# 45 McLaren St

## North Sydney

Response to Council RFI

February 2024

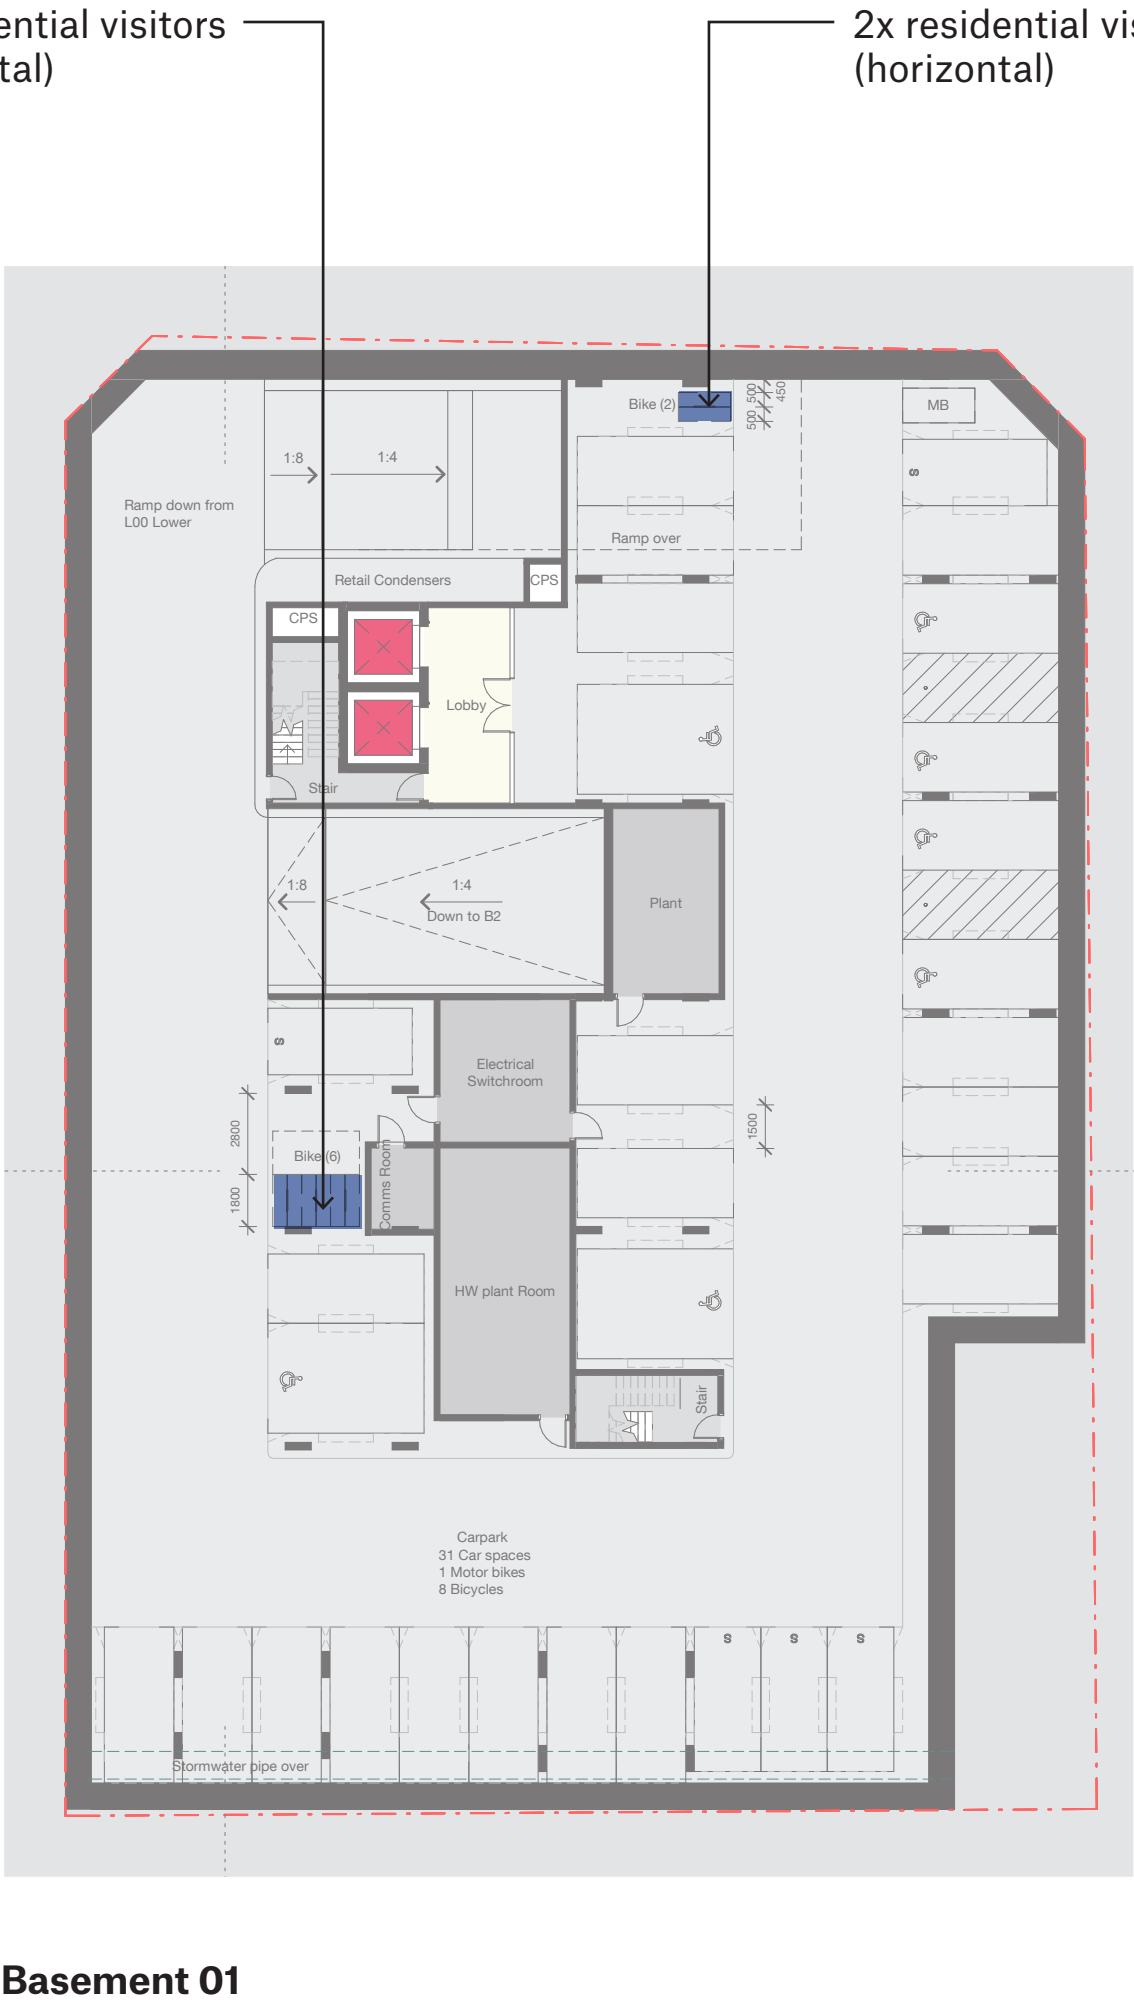
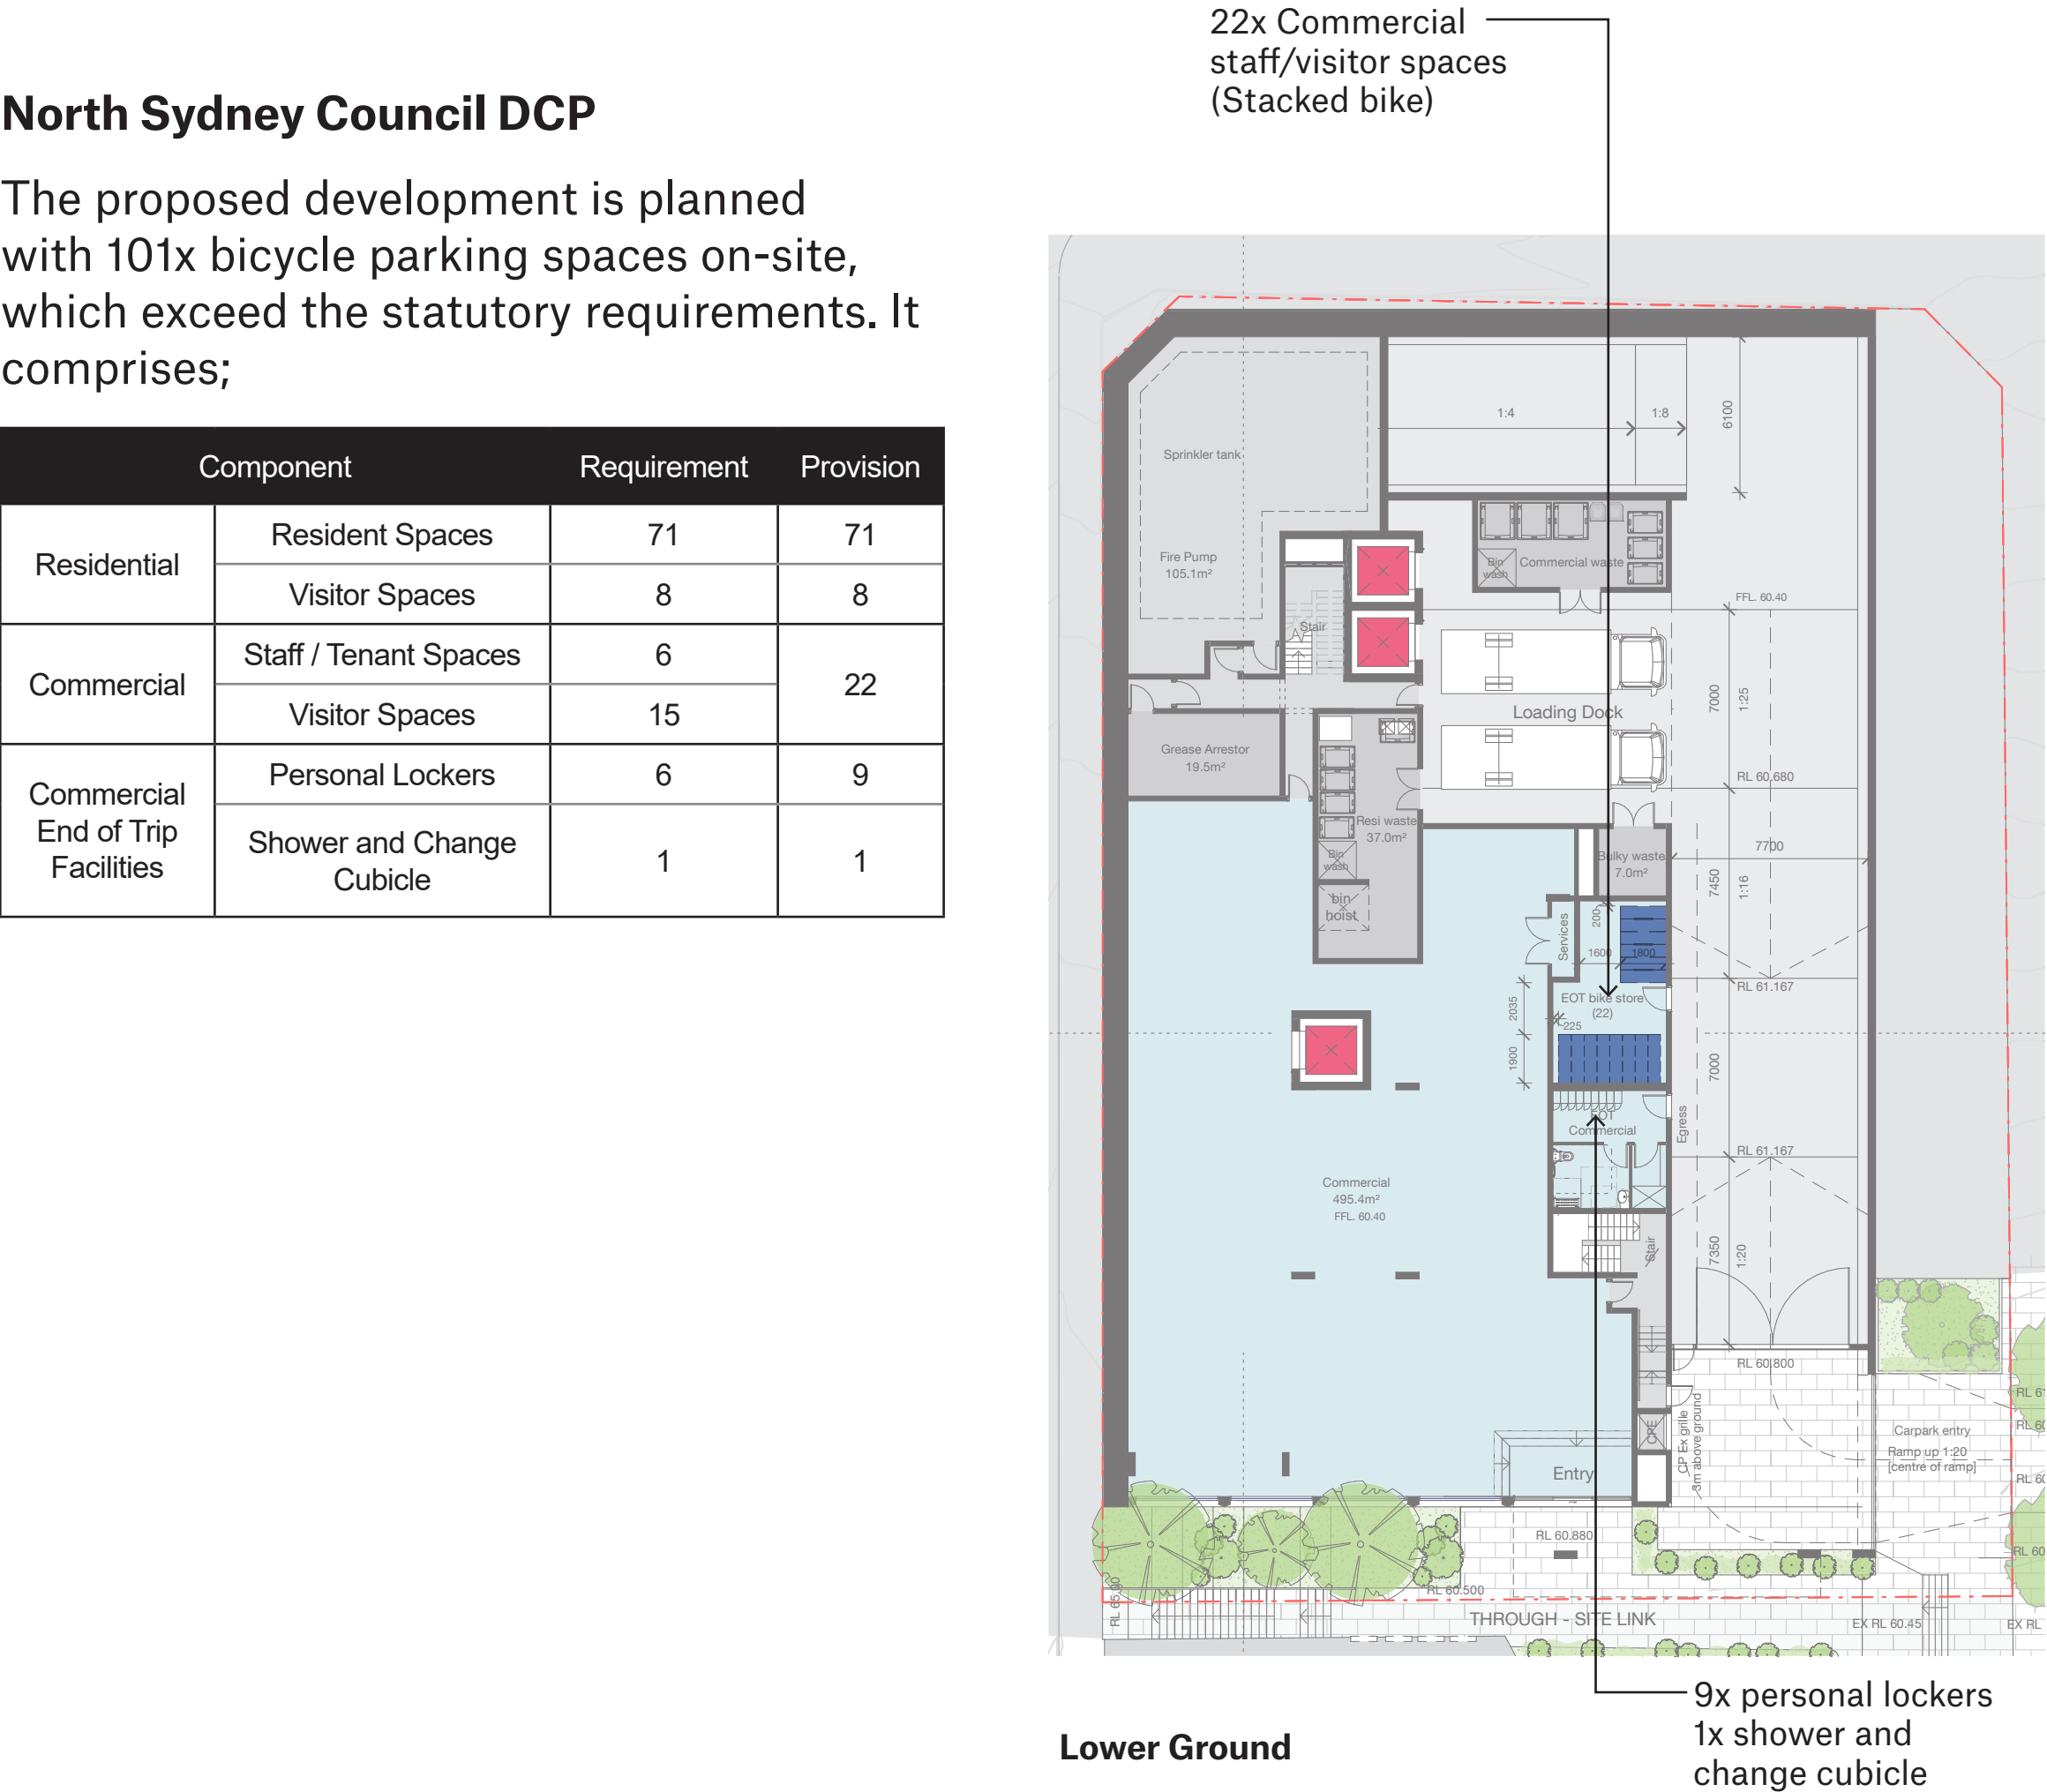
*All aspects of bicycle parking and facilities must comply with the **Australian Standard AS2890.3** and **Council's DCP**. Details of all bike storage/parking spaces required by the DCP must be shown on the architectural plans*

The proposed development is planned with 101x bicycle parking spaces on-site, which exceed the statutory requirements. It comprises;

# Building Core Proposed DA

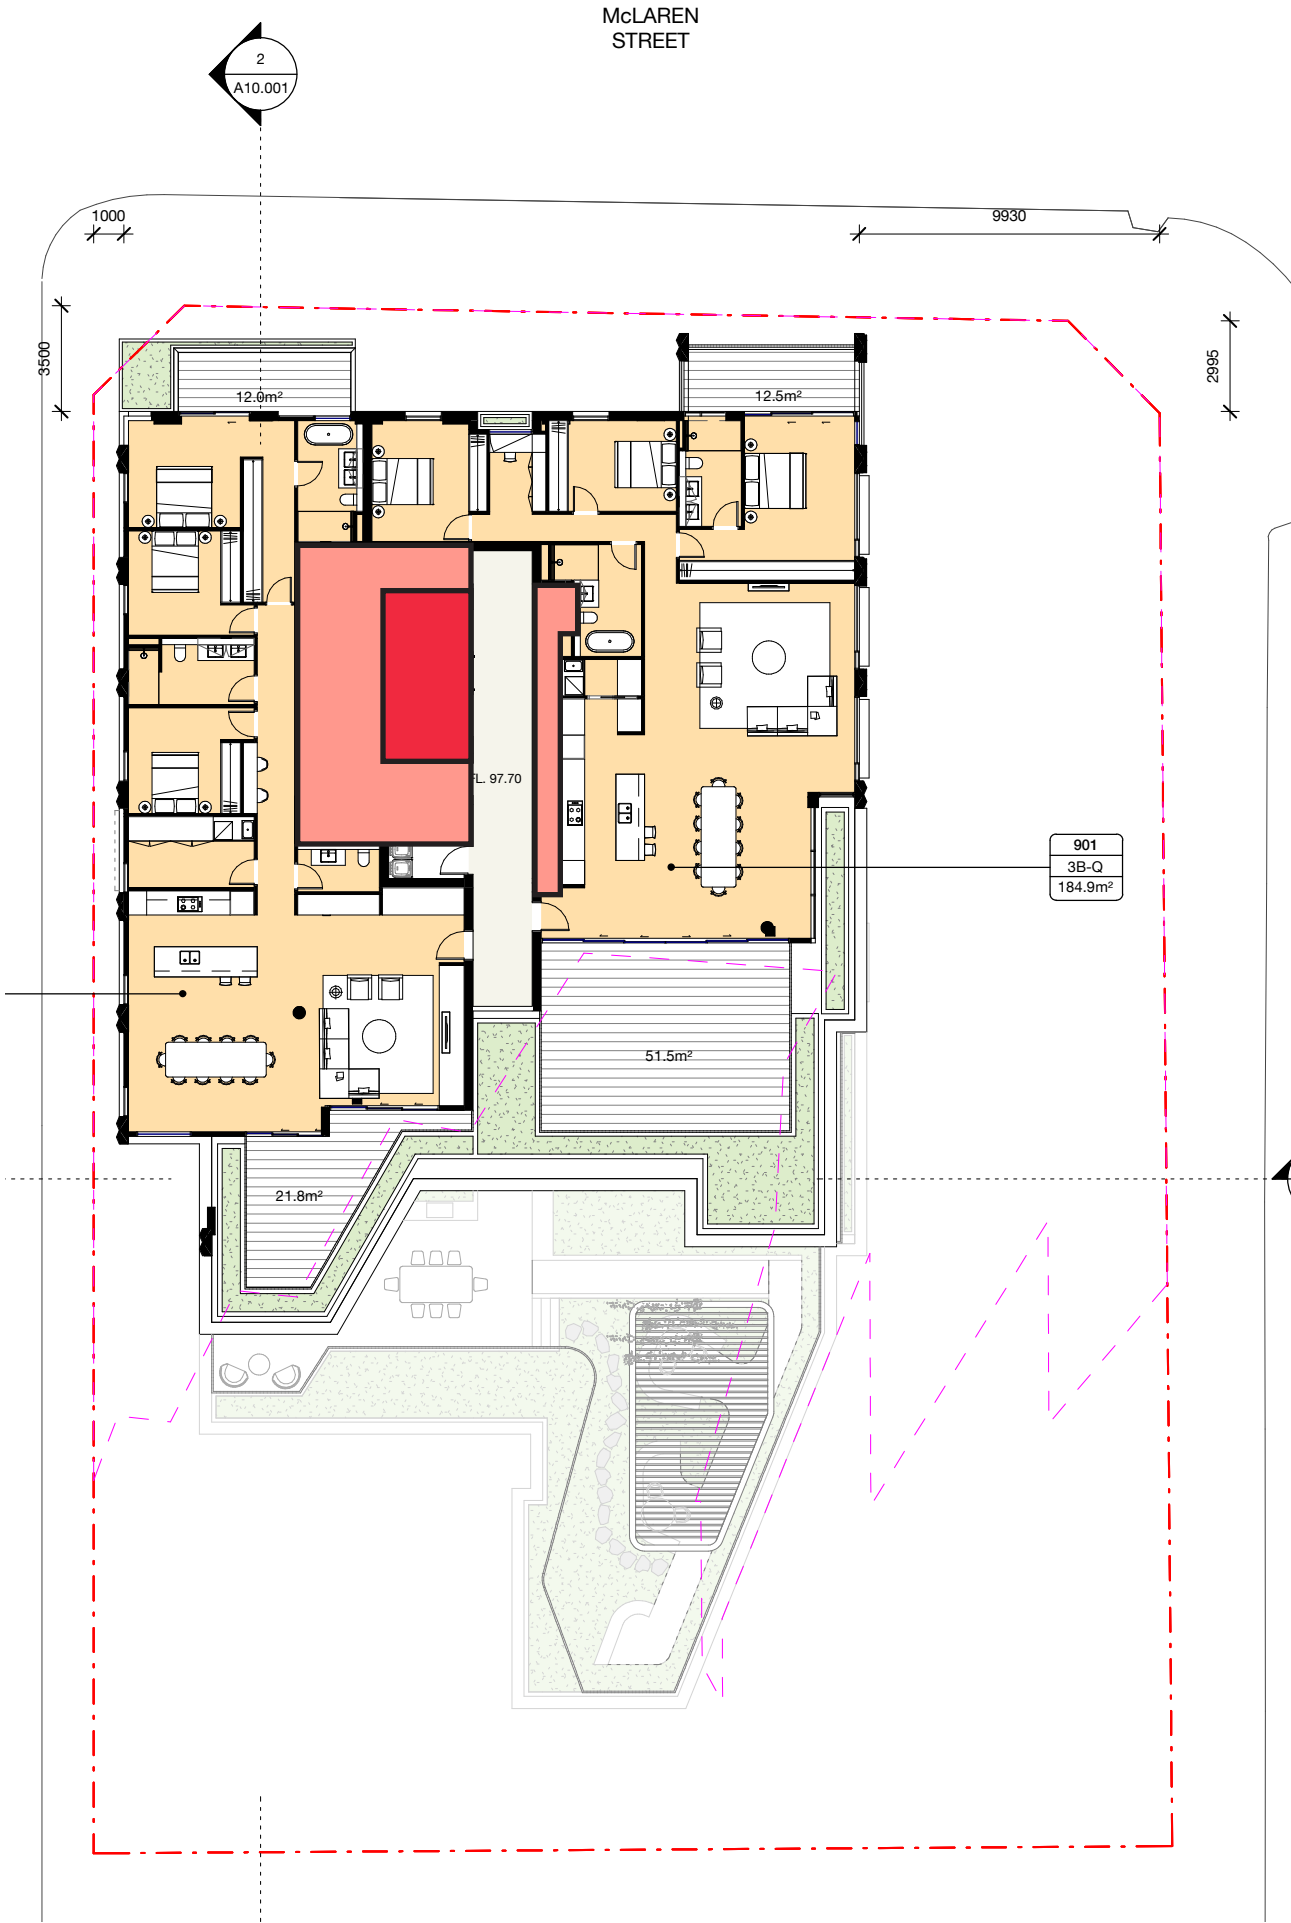
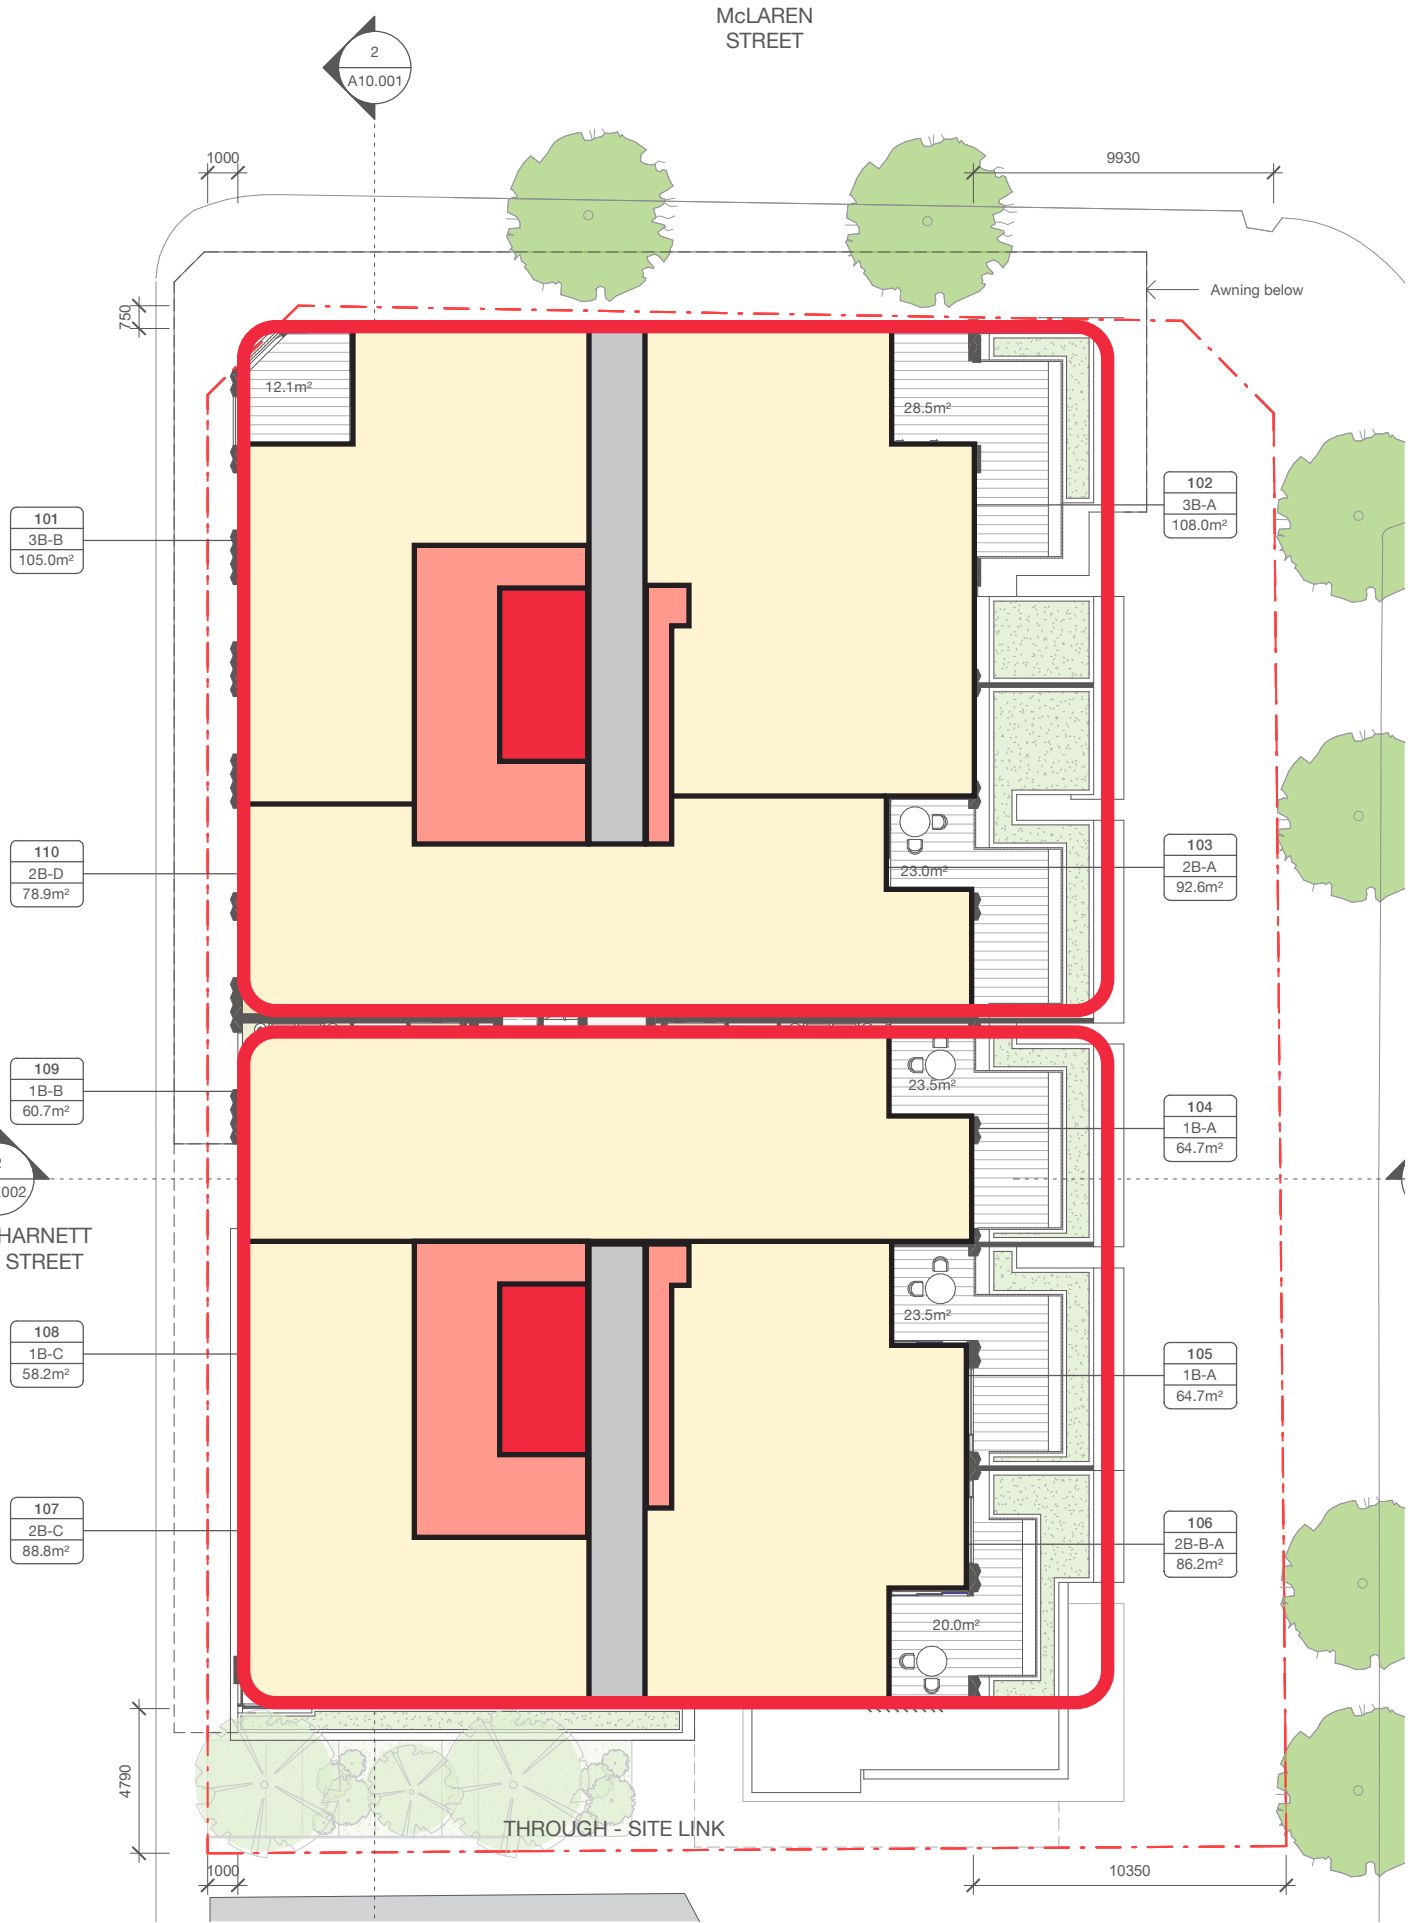
*Common circulation - The 35m long **internal corridor serving up to 10 apartments** per floor is unacceptable. The ADG limits this to eight dwellings. **A second core** and / or an open stair **should be considered** up to level 6, which could also allow enhanced daylight penetration to the corridor.*

North Sydney Council have questioned whether single core design is sufficient and whether second core may need to be introduced.

Due to its stepped form allowing solar access to future Ward St Precinct Plaza, the only feasible location for high-rise core to the building is North West

However, it is worth noting that ADG also notes if this cannot be achieved, no more than 12 apartments should be provided off a circulation core on a single level

- **Level 1** - 10 units
- **Level 2 & 3** - 9 units
- **Level 4 & up** - No more than 8 units
